# UNITED STATES PATENT AND TRADEMARK OFFICE

APPLICATION NO.	FILING DATE	FIRST NAMED INVENTOR	ATTORNEY DOCKET NO.	CONFIRMATION NO.
10/662,707	09/15/2003	Masaki Terashima	32758US6	1017

## Office Action Summary

## **DETAILED ACTION**

FIG. 21

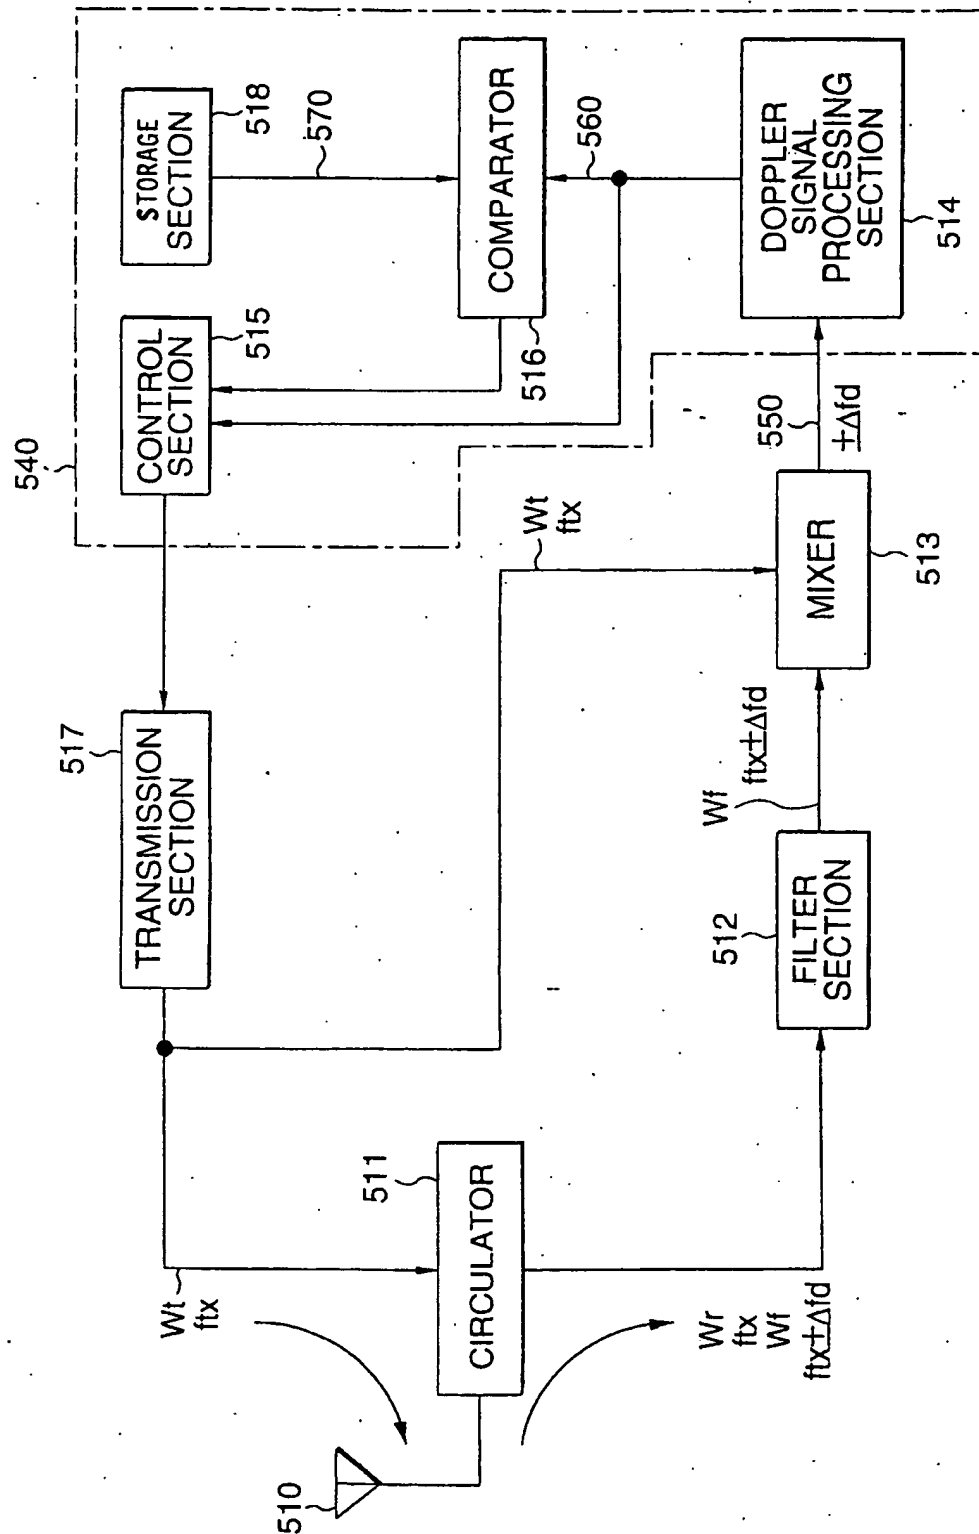
1. The drawings are objected to because in Fig. 21, box 540 has not been identified in the specification, specifically at page 49, lines 12-21. Further, "warning signal 580" (page 50, line 14) is not shown in Fig. 21. Corrected drawing sheets in compliance with 37 CFR 1.121(d) are required in reply to the Office action to avoid abandonment of the application. Any amended replacement drawing sheet should include all of the figures appearing on the immediate prior version of the sheet, even if only one figure is being amended. The figure or figure number of an amended drawing should not be labeled as "amended." If a drawing figure is to be canceled, the appropriate figure must be removed from the replacement sheet, and where necessary, the remaining figures must be renumbered and appropriate changes made to the brief description of the several views of the drawings for consistency. Additional replacement sheets may be necessary to show the renumbering of the remaining figures. Each drawing sheet submitted after the filing date of an application must be labeled in the top margin as either "Replacement Sheet" or "New Sheet" pursuant to 37 CFR 1.121(d). If the changes are not accepted by the examiner, the applicant will be notified and informed of any required corrective action in the next Office action. The objection to the drawings will not be held in abeyance.
